# Work Order ID 107779

Item Name: Crosstube Assembly, Mid Fwd

<b>DART AEROSPACE LTD</b> HAWKESBURY, ONTARIO, CANADA	
DRAWING NO. D206-667-147	REV. A SHEET 1 OF 4
TITLE CROSSTUBE ASSY (206L MID FWD)	SCALE NTS

DRAWING NO. D206-667-147	TITLE CROSSTUBE ASS'Y (206L MID FWD)	REV. A	<b>DART AEROSPACE LTD ENGINEERING ORDER</b>		D.E.O. NO. D206-667-147-A-1	SHEET NO. SHEET 1 OF 1	SCALE NTS
DRAWN 90	CHECKED ADS	MFG. APPR. JB	APPROVED MD		DE APPR. H		
DATE 11.07.15	DATE 11.07.20	DATE 11.07.21	DATE 11/07/21		DATE 11.07.21

**DETAIL P**  
BONDING STRAP INSTALLATION 2 PL

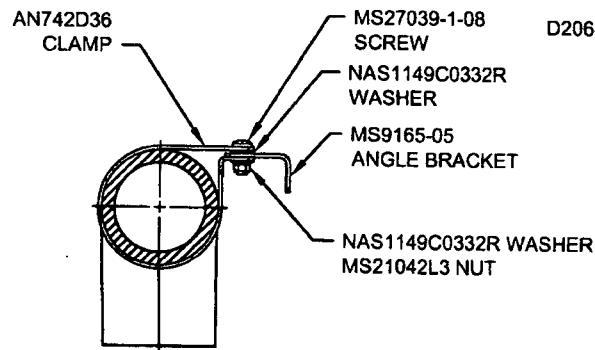
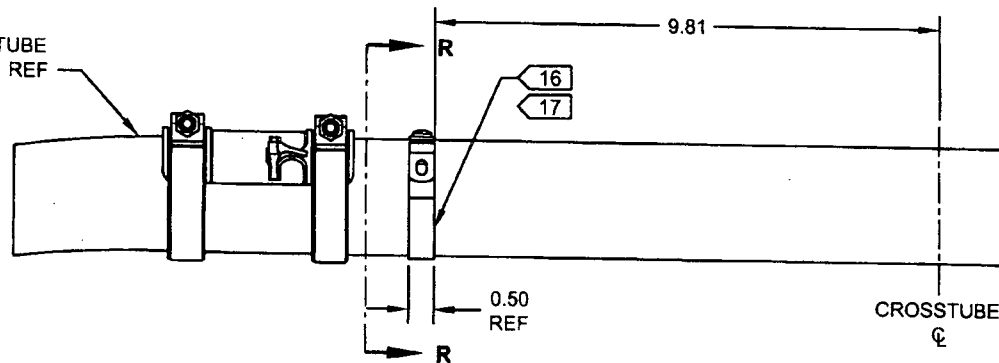
ADD ELECTRICAL GROUNDING STRAP

ITEM	QTY -147	PART NUMBER	DESCRIPTION
1	X	D206-667-147	CROSSTUBE ASSEMBLY (206L MID FWD)
⚡			
10	2	AN742D36	CLAMP
11	2	MS9165-05	ANGLE BRACKET
12	2	MS21042L3	NUT (OR MS21042-3)
13	2	MS27039-1-08	SCREW
14	4	NAS1149C0332R	WASHER (OR AN960C10L)

- 16) MASK AREA UNDER CLAMP PRIOR TO PAINTING
- 17) SEAL EDGES WHERE AN742D36 CLAMP MEETS WITH THE CROSSTUBE USING SIKAFLEX-241/-291 OR MIL-S-8802 CLASS B2 OR PROSEAL 890 SEALANT
- 18) PERFORM RESISTANCE CHECK TO ENSURE MAX RESISTANCE IS 10 MILLIOHMS
